REPLACEMENT SYSTEM VARIANCE REQUEST

Town of AUGUSTA

Permit No. 3217 E

6-8-95 Amendment to Permit #3217

SUBSURFACE WASTEWATER DISPOSAL PLAN

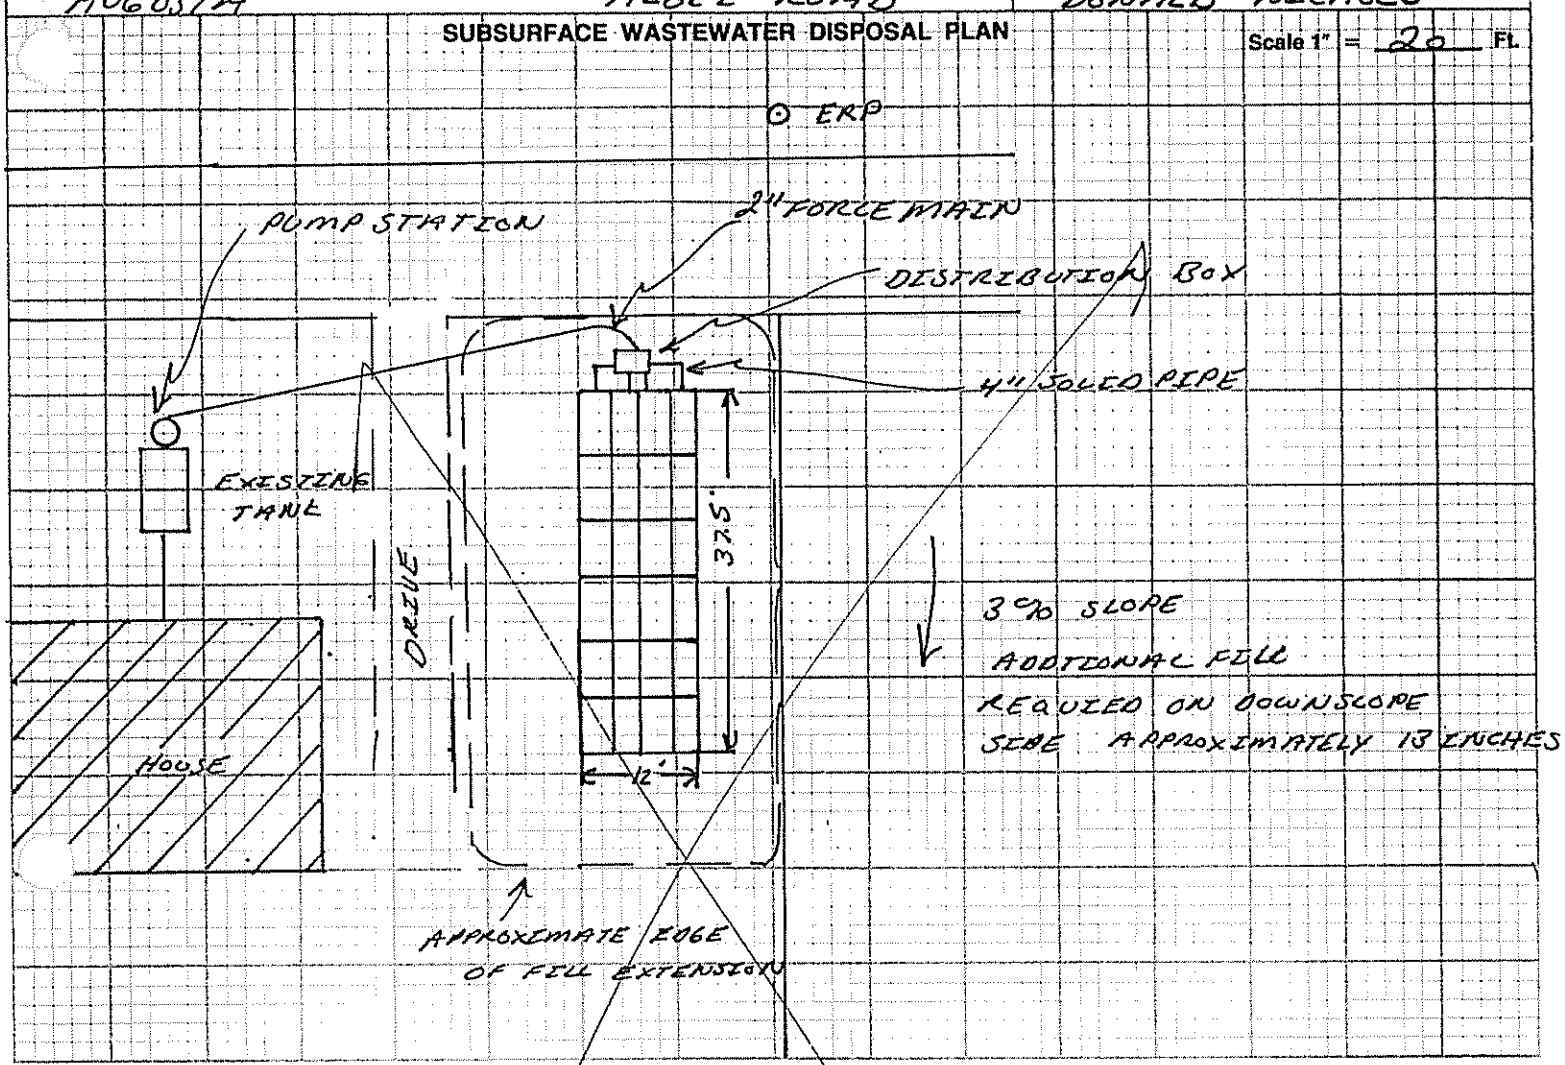
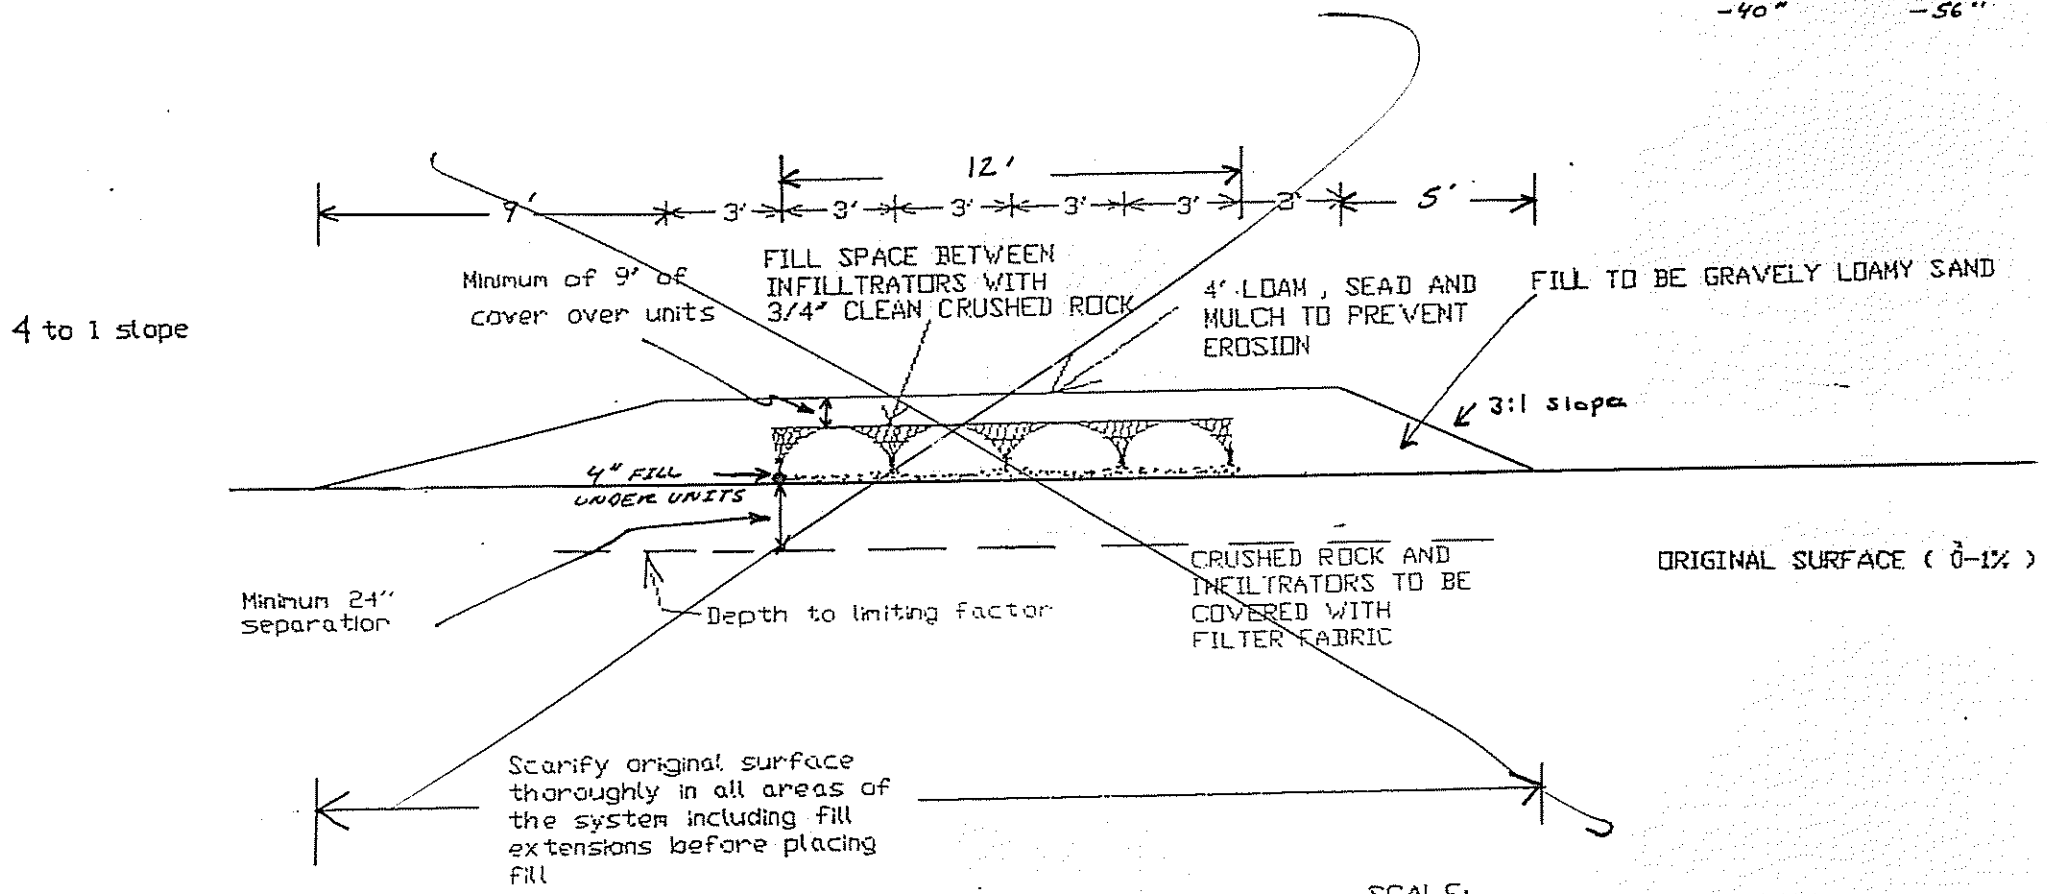
1. Fill extension Grade—to 3:1 3:1 SLOPE ON SIDE NEAR PROPERTY LINE
2. AND ROAD.
3.

SITE PLAN Scale 1" = 50 Ft.

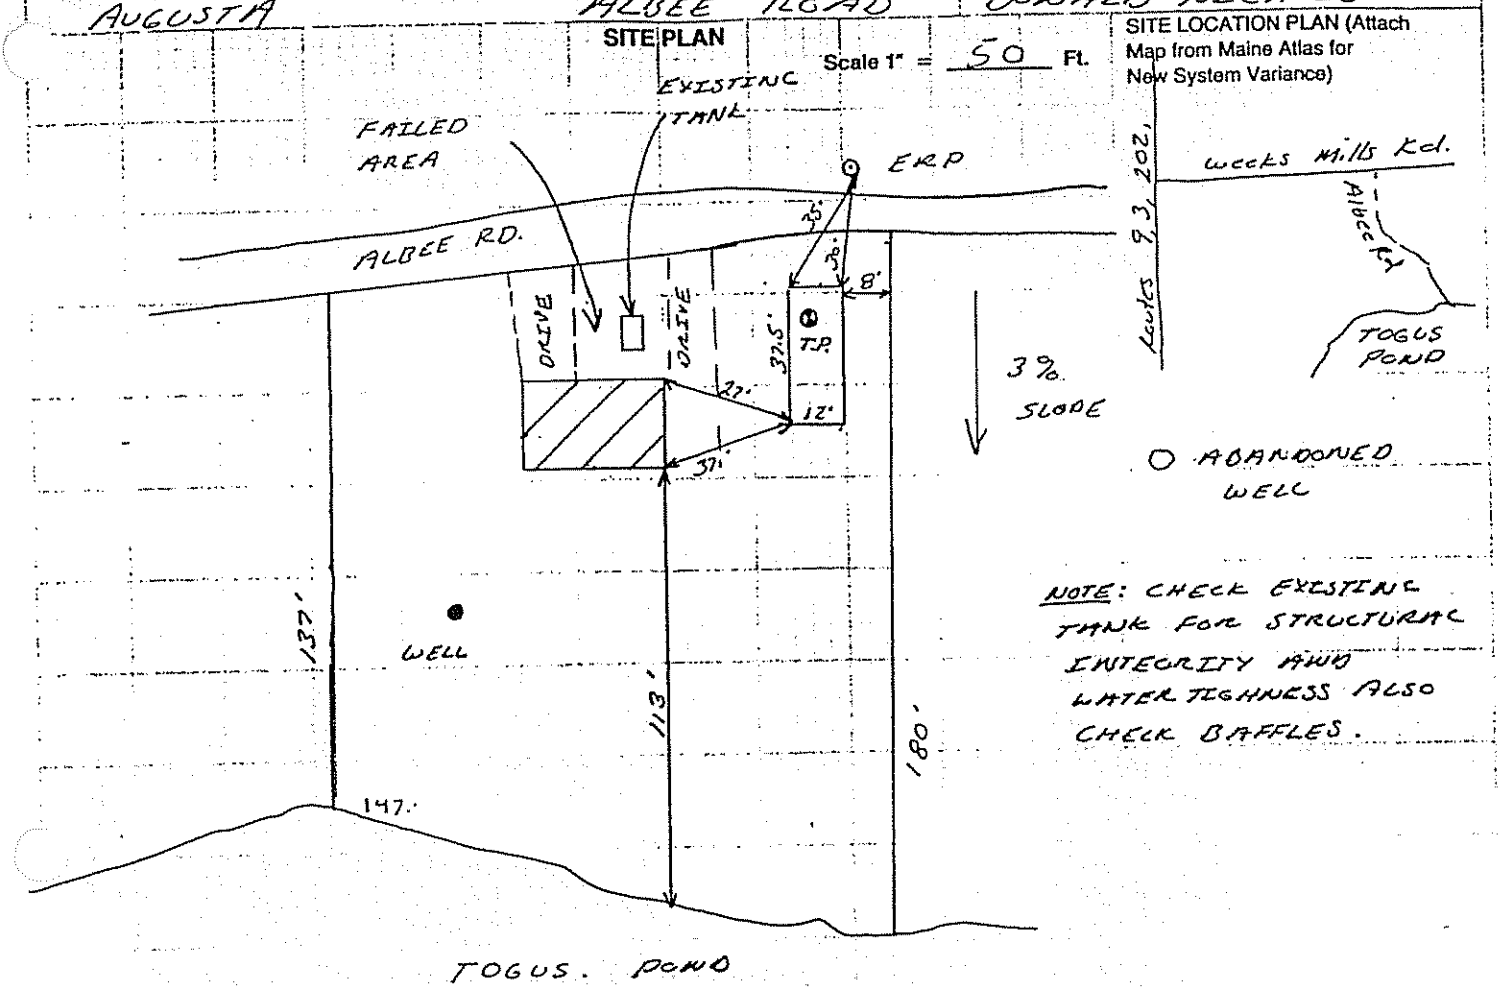
DEPTH BELOW MINERAL SOIL SURFACE (Inches)	Texture	Consistency	Color	Mottling
0–6	FINE SANDY LOAM	FRIABLE	BROWN	FREE
6–10			ORANGE BROWN	
10–15			YELLOW BROWN	
15–20	SANDY LOAM	FIRM	OLIVE BR	FEW FAINT
30	POSSIBLE LEDGE Rocks Confirmed 6-1-95 Not Ledge

SUBSURFACE WASTEWATER DISPOSAL PLAN

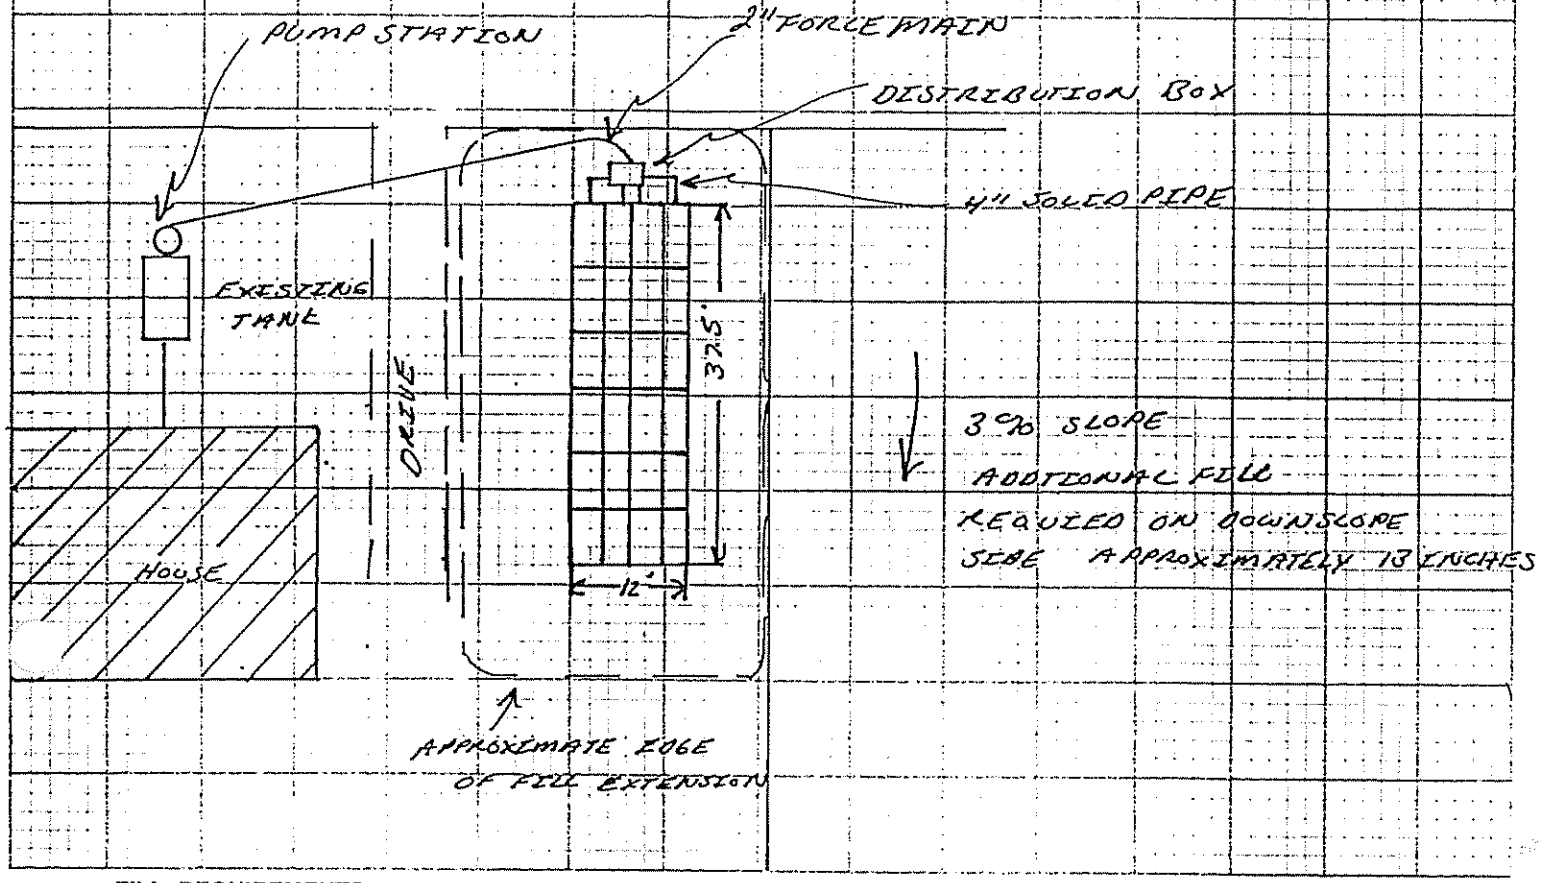
Reference Elevation is 0.00
Bottom of Disposal Area ~~56"~~
Top of Distribution Lines or Chambers ~~40"~~

Elevation Correction 6-2-95
Top of Infiltrators - 54"
Bottom Infiltrators - 66
Eugene Dube Sc 241
[illegible]
